**STAFF REVIEW AND RECOMMENDATIONS
PUBLIC HEARING
APRIL 7, 2021**

ABBREVIATED PLAT: INGOLF GRAHAM

CASE #: 2021-036

REQUEST: The request is to create three lots from Tax Parcel A17 (Parcel 2, Waiver 92-20-PWm), to be known as **INGOLF GRAHAM SUBDIVISION**, containing 10.0 acres +/- . Located directly west of S. Ingolf Street and south of E. Maud Road lying within the NE ¼ Section 12, Township 17 North, Range 02 East, Seward Meridian, Alaska. Proposed Lot 3 is a flag lot, pursuant to MSB 43.20.300(E).

PALMER, ALASKA
INGOLF GRAHAM SUBDIVISION
SITE PLAN - EXISTING CONDITIONS
TOPOGRAPHY

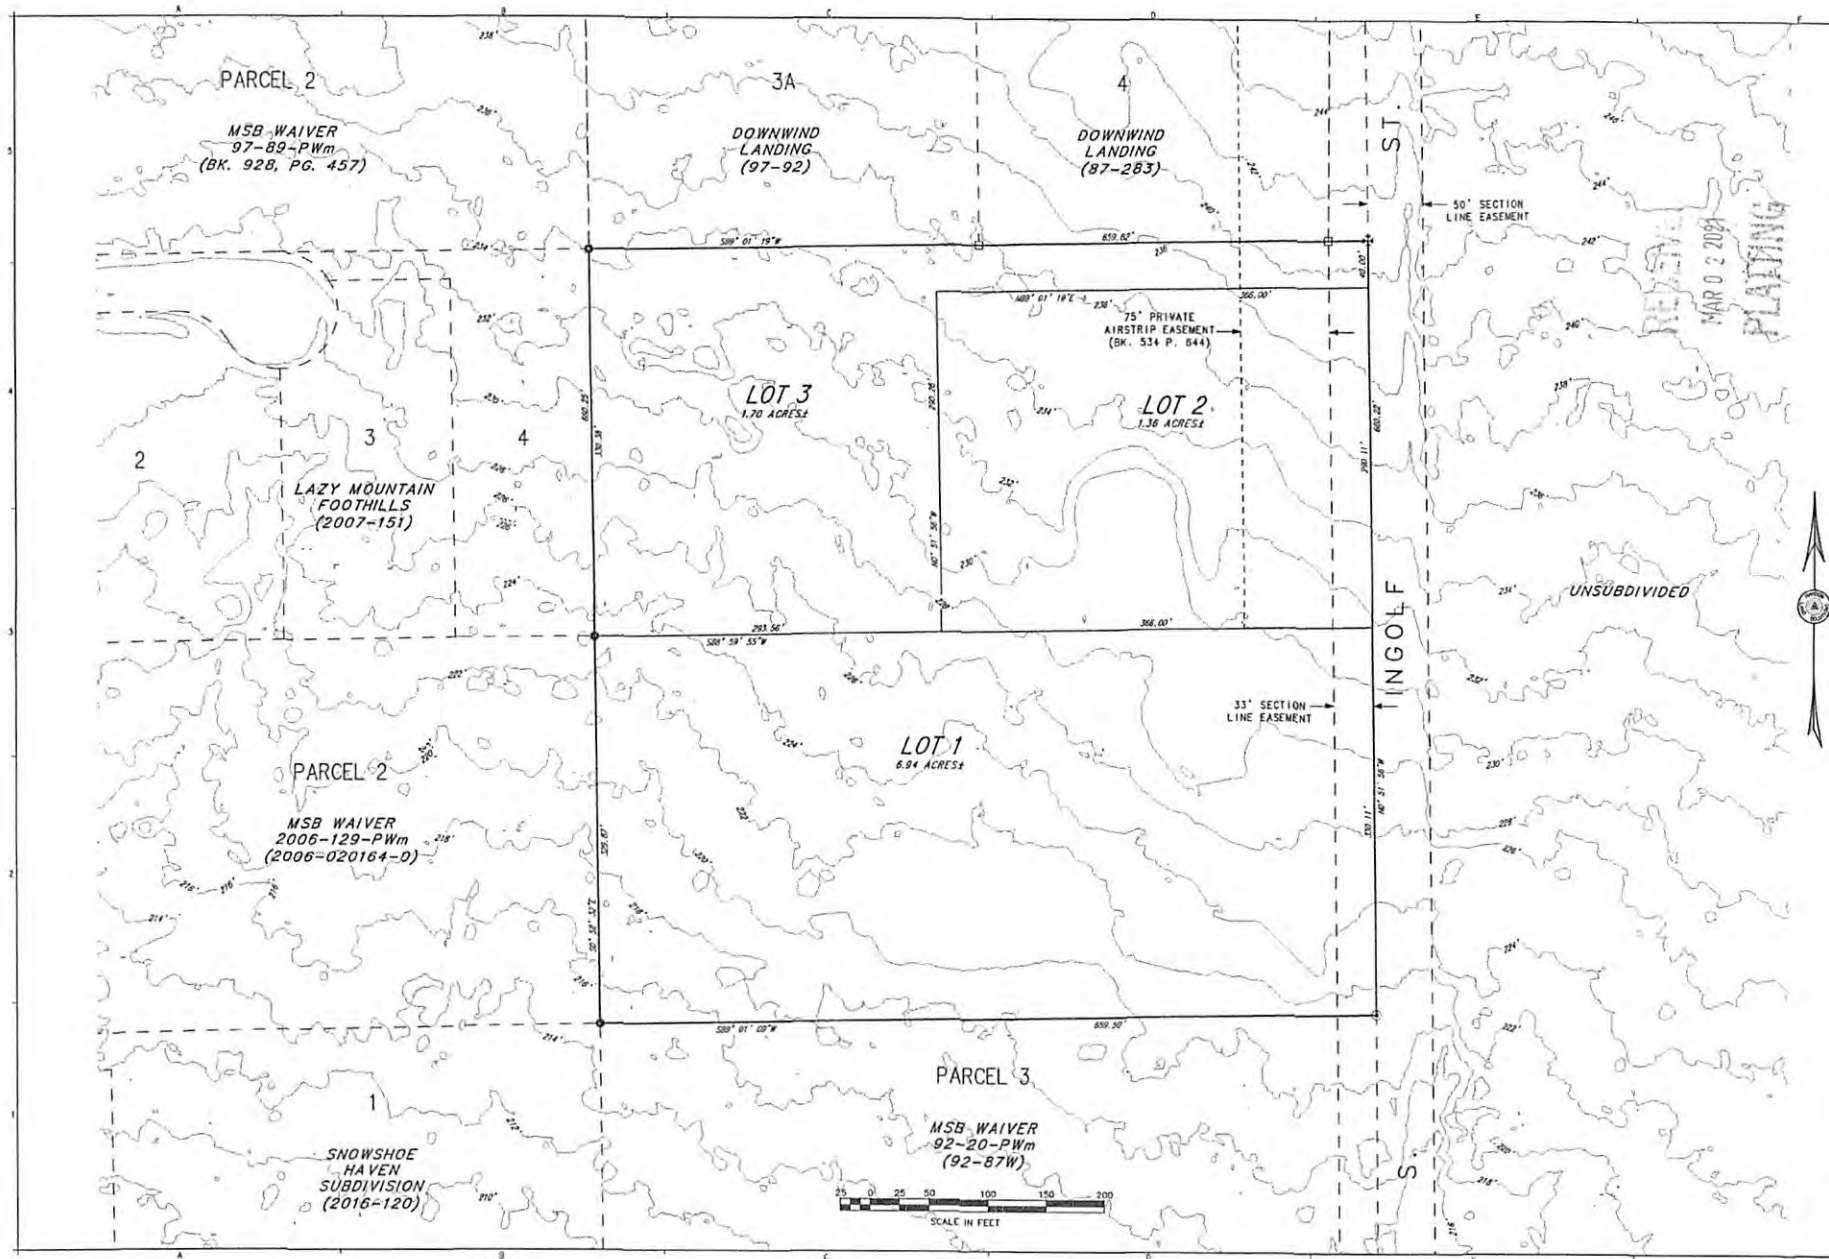
As-Built: The surveyor provided as-built information and topographic contours at **Exhibit C** as required by MSB 43.15.016. Multiple structures are shown on the As-Built Survey. Based on the information provided by the surveyor, all structures shown are compliant with the setbacks requirements per MSB 17.55 *Setbacks*.

A PLAT OF
**INGOLF GRAHAM
SUBDIVISION**

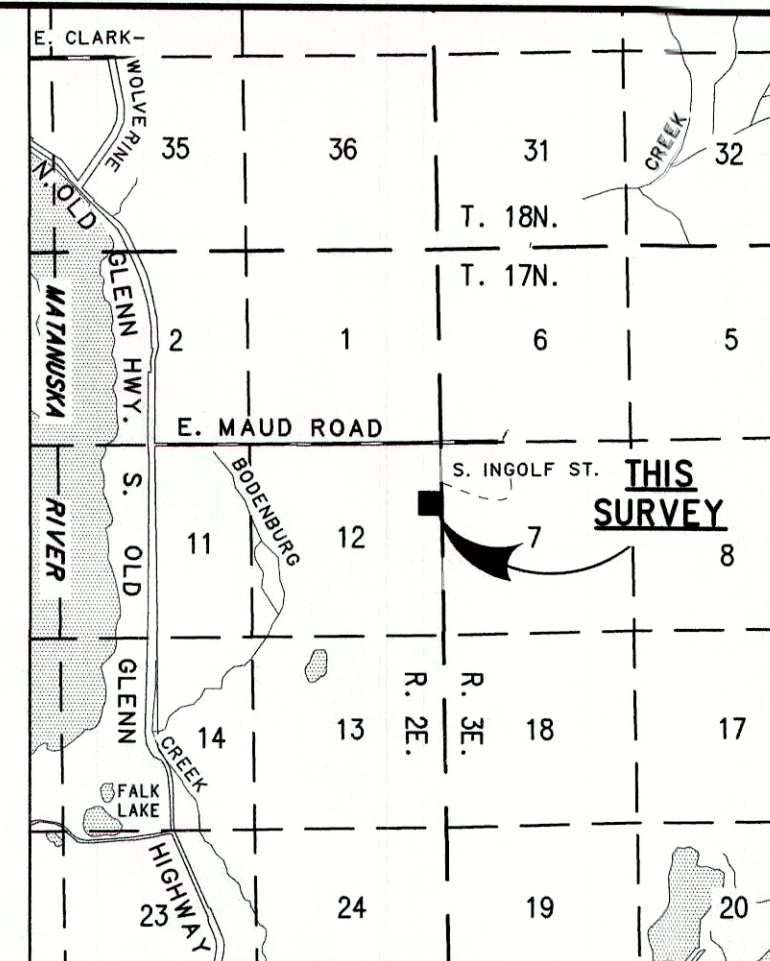
DISCUSSION: The proposed subdivision is south of E. Maud Road, west of S. Ingolf Street and south of Downwind Landing Subdivision. The proposed subdivision would create three lots from the parent parcel. All lots will take access from S. Ingolf Street. Proposed Lot 3 is shown as a 40" wide flag lot. Pursuant to MSB 43.20.300(E)(6)(b), the flagpole width for any lot greater than 2.5 acres must be 60' wide. Either enlarge the width of the flagpole, or reduce the size of Lot 3 to under 2.5 acres (***Recommendation #6***).

There is a driveway from this parcel onto Ingolf St. Please have them apply for their driveway permit.

Cheryl,
The only concern is the pole section of the created flag. I have attached the pertinent part of Appendix D.

MTA would like to request the 15' MEA easement to be changed to a 15' T&E easement.
